**Economic and Social Council**Distr.: General
2 March 2015

Economic Commission for Europe**Inland Transport Committee****World Forum for Harmonization of Vehicle Regulations****Working Party on Passive Safety****Fifty-seventh session**

Regulation No. 129 (Enhanced Child Restraint Systems)**Proposal for Proposal for the 01 series of amendments to Regulation No. 129 (Enhanced Child Restraint Systems)****Submitted by the expert from France***

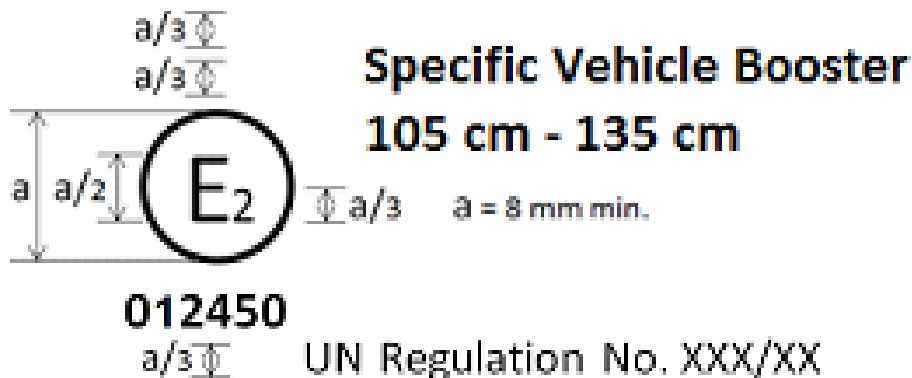
Annex 2, insert at the end two new approval marks, to read:

The Enhanced Child Restraint System bearing the above approval mark is a device not capable of being fitted in every vehicle but capable of being used for the 105 cm - 135 cm size range; it is approved in France (E 2) under the number 012450. The approval number indicates that the approval was granted in accordance with the requirements of the Regulation concerning the approval of Specific Vehicle Booster Enhanced Child Restraint Systems used onboard of motor vehicles as amended by the 01 series of amendments. In addition the name of the regulation has to be identified on the approval mark followed by the series of amendment according to which the approval has been granted."

Figure 1
Dimensions in mm of the seat and the seat cushions

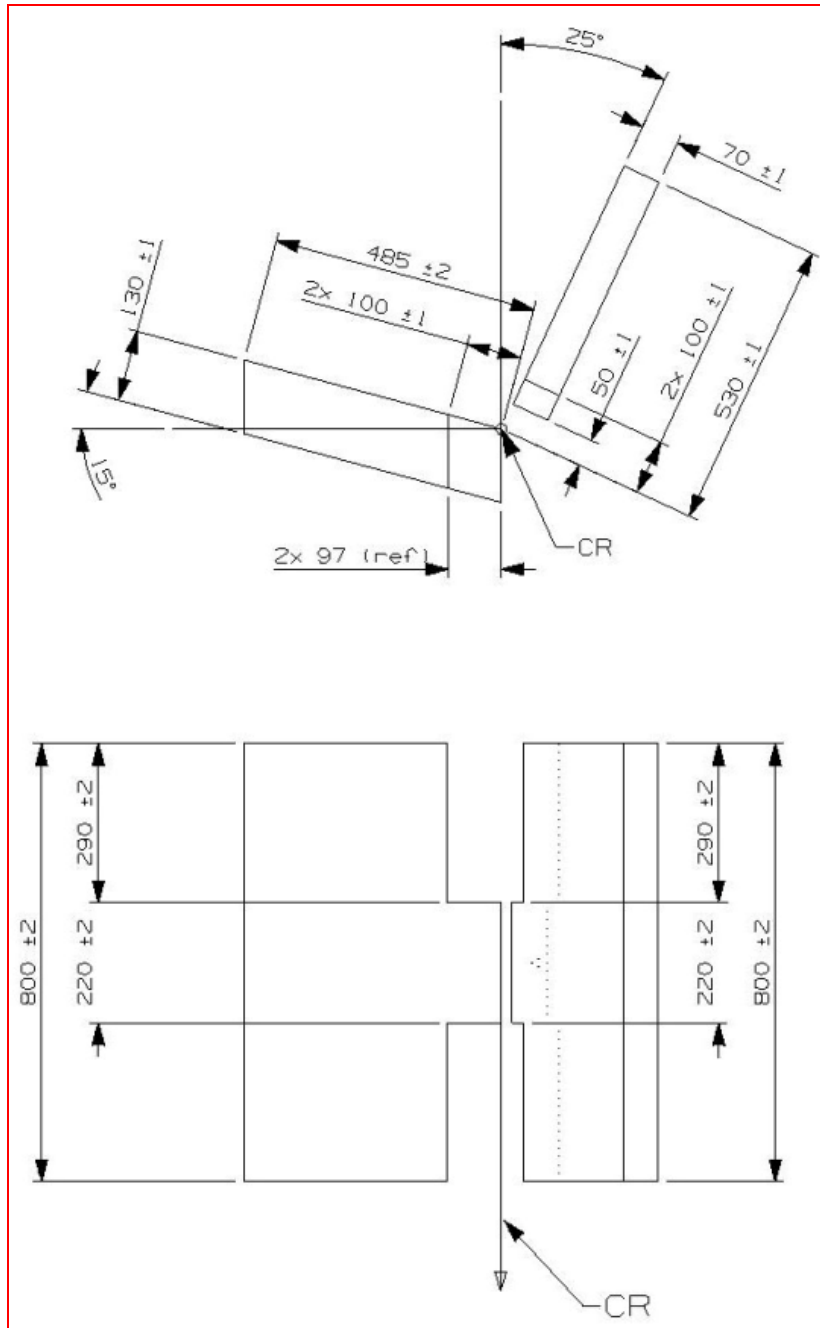
"Annex 6 - Appendix 1

Top View – Bench with Isofix anchorages (Tolerance general: ±2 mm)

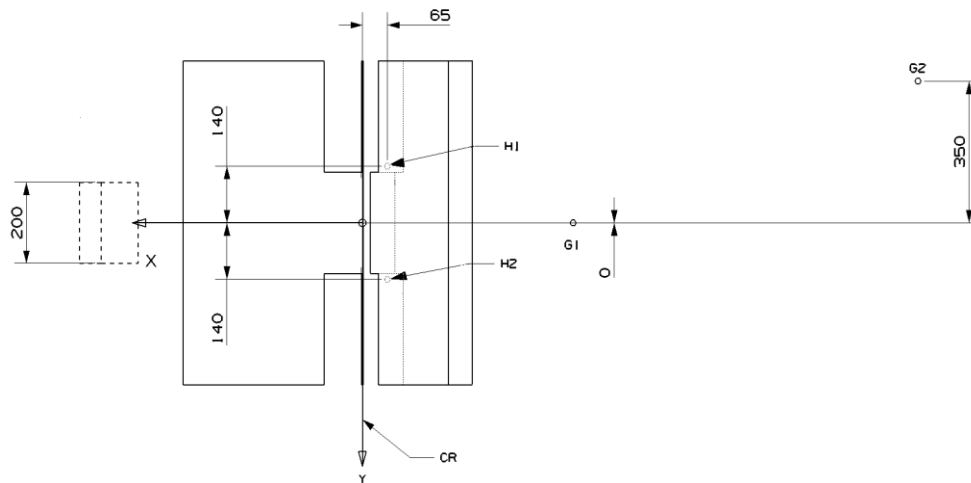
Annex 6, Appendix 2, amend to read:

1. The anchorages shall be positioned as shown in the figure below.
2. **Enhanced** Child Restraint Systems in the i-Size "universal", "specific" and "restricted" categories shall use the following anchorage points: H₁ and H₂.

Figure 3
Top View – Bench with belt anchorages (Tolerance general: ± 2 mm)

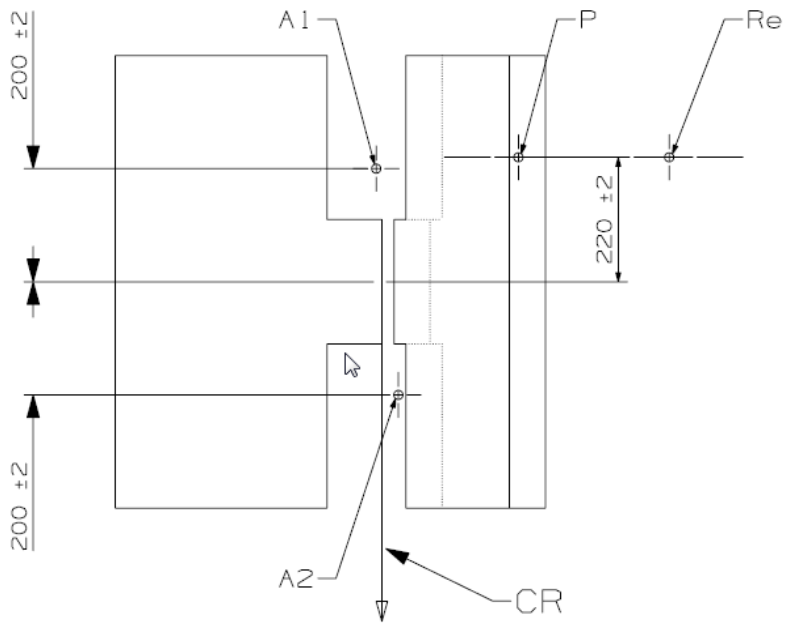
Definition of belt anchorages

The following table gives the belt anchorages points.

Figure 1
Standard seat belt configurations

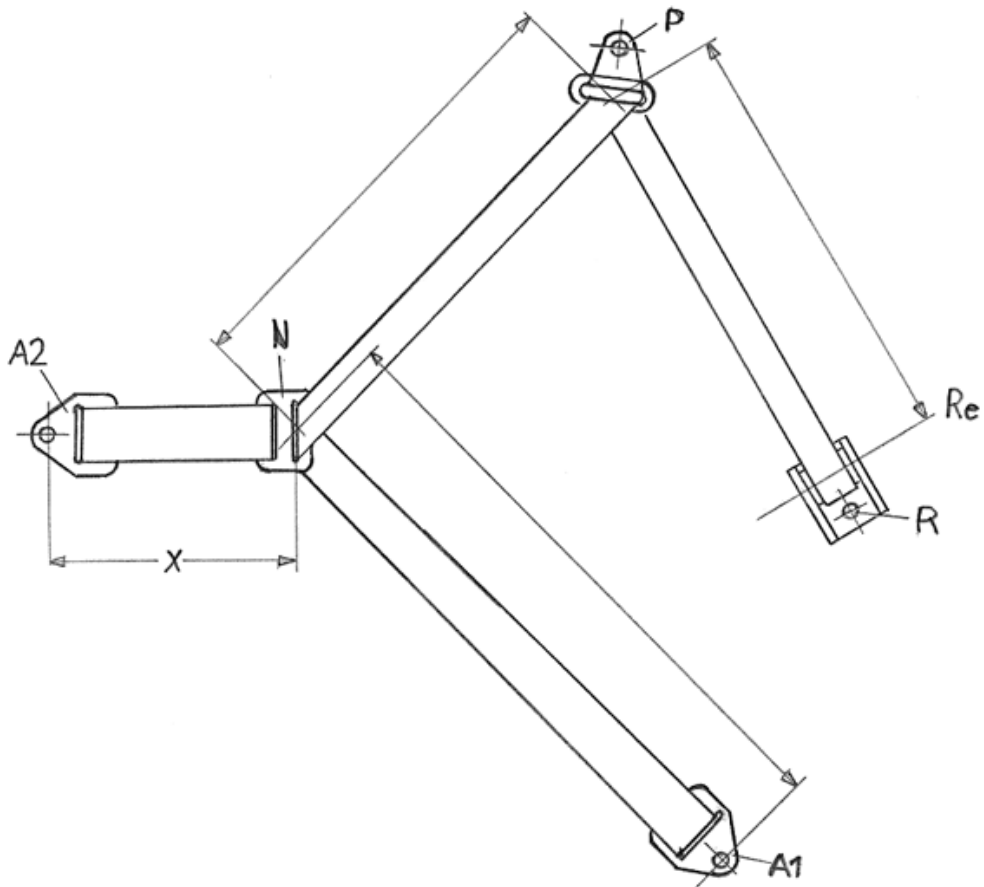
1. The safety-belt for the dynamic test and for the maximum length requirements shall be made according to one of the two configurations shown in Figure 1. These are a three-point retracting belt system.

The value of X in Figure 1 below is 200 ± 5 mm. The effective strap length between A1 and the centre line of the retractor spool Re (when the webbing is fully extracted including the minimum length of 150 mm for testing of Enhanced Child Restraint System shall be $[2820] \pm 5$ mm when measured in a straight line without load and on a horizontal surface. This length may be increased for the testing of restricted categories; for all categories with the Enhanced Child Restraint System installed, there shall be a minimum of 150 mm of strap length on the retractor spool.

Figure 1
Measuring Device for a Universal Booster Cushion

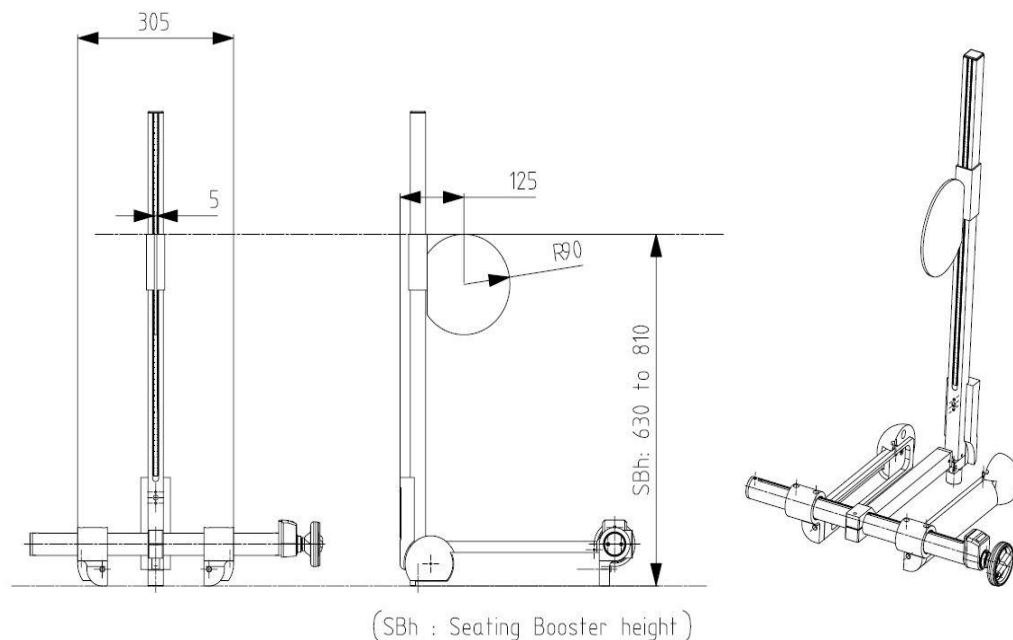
1. Definition of the measuring device to assess a universal Booster Cushion

The measuring device to assess a universal Booster Cushion is described in Figure 1. This measuring device shall have a mass of 10 ± 1 kg.

Figure 2
Installation of the Measuring Device to measure Z5 and Z95

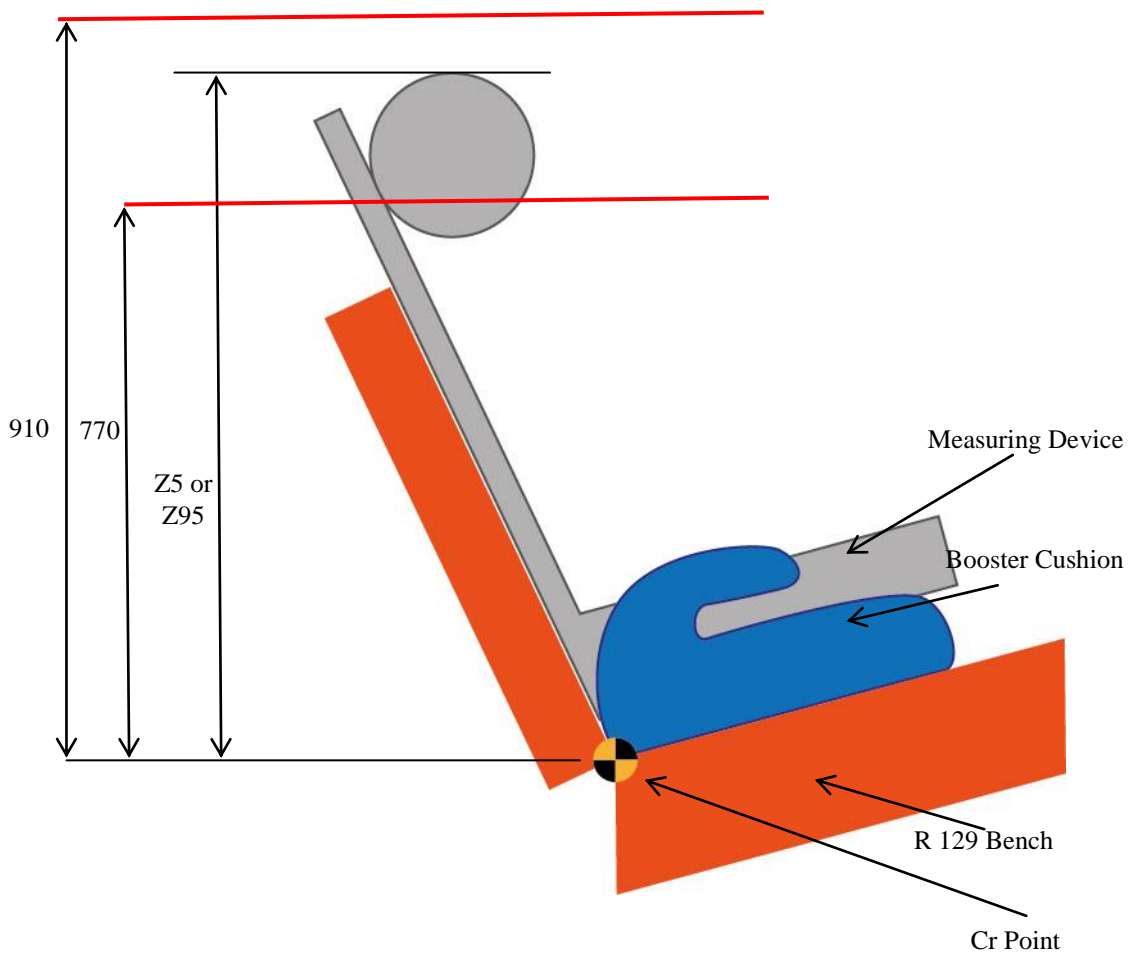
2. Procedure to evaluate a Universal Booster Cushion

- 2.1. Using Table 1 below, adjust the Seating Booster height (SBh) to the 5th percentile seating height of the lower stature defined for the Booster Cushion.
- 2.2. Position the Booster Cushion on the Regulation No. 129 test bench.
- 2.3. Position the Booster Measuring Device on the Booster Cushion as defined in Figure 2.
- 2.4. Measure the upper position of the cylinder relative to the Cr point in the Z direction: Z5.
- 2.5. Using Table 1 below, adjust the Seating Booster height (SBh) to the 95th percentile seating height of the taller stature defined for the Booster Cushion.
